Intel® 815 Chipset Platform for Use with Universal Socket 370

Design Guide Update

October 2002

Document Number: 298308-002

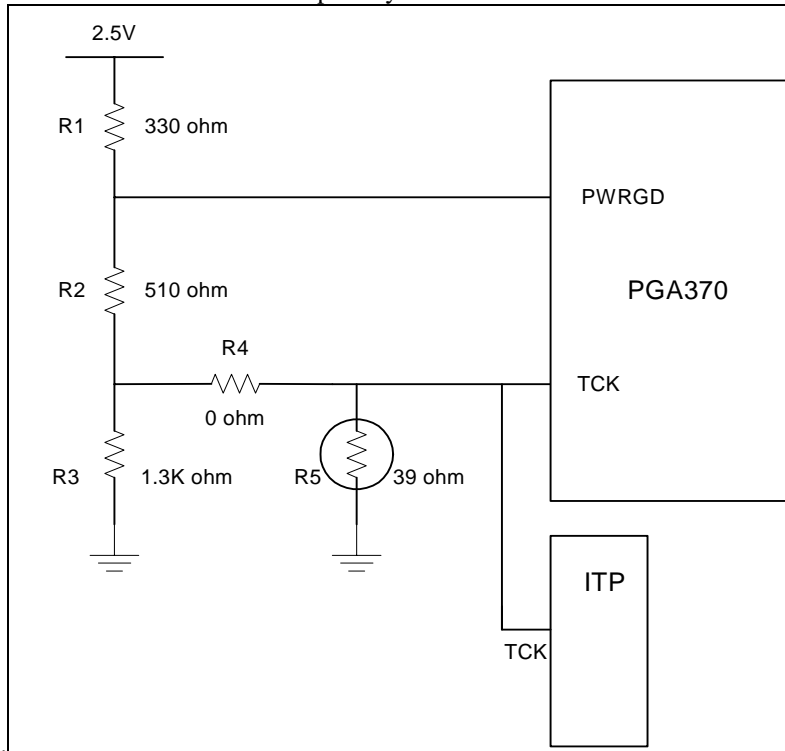
To prevent the risk of power-on boot failures, a platform workaround is required. The system must provide a rising edge on the TCK signal during the power-on sequence that meets all of the following requirements:

- Rising edge occurs after VCC_CORE is valid and stable
- Rising edge occurs before or at the de-assertion of RESET#
- Rising edge occurs after all VREF input signals are at valid voltage levels
- TCK input meets the VIH min (1.3 V) and max (1.65 V) spec requirements

Specific workaround implementations may be platform-specific. The following examples have been tested as acceptable workaround implementations.

Note: the example workaround circuits attached require circuit modification for ITP tools to function correctly. These modifications must remove the workaround circuitry from the platform and may cause systems to fail to boot. Review the accompanying notes with each workaround for ITP modification details. If the system fails to boot when using ITP, issuing the ITP 'Reset Target' command on failing systems will reset the system and provide a sufficient rising edge on the TCK pin to ensure proper system boot.

For Production Boards:
Depopulate R5

To use ITP:
Install R5, Depopulate R4
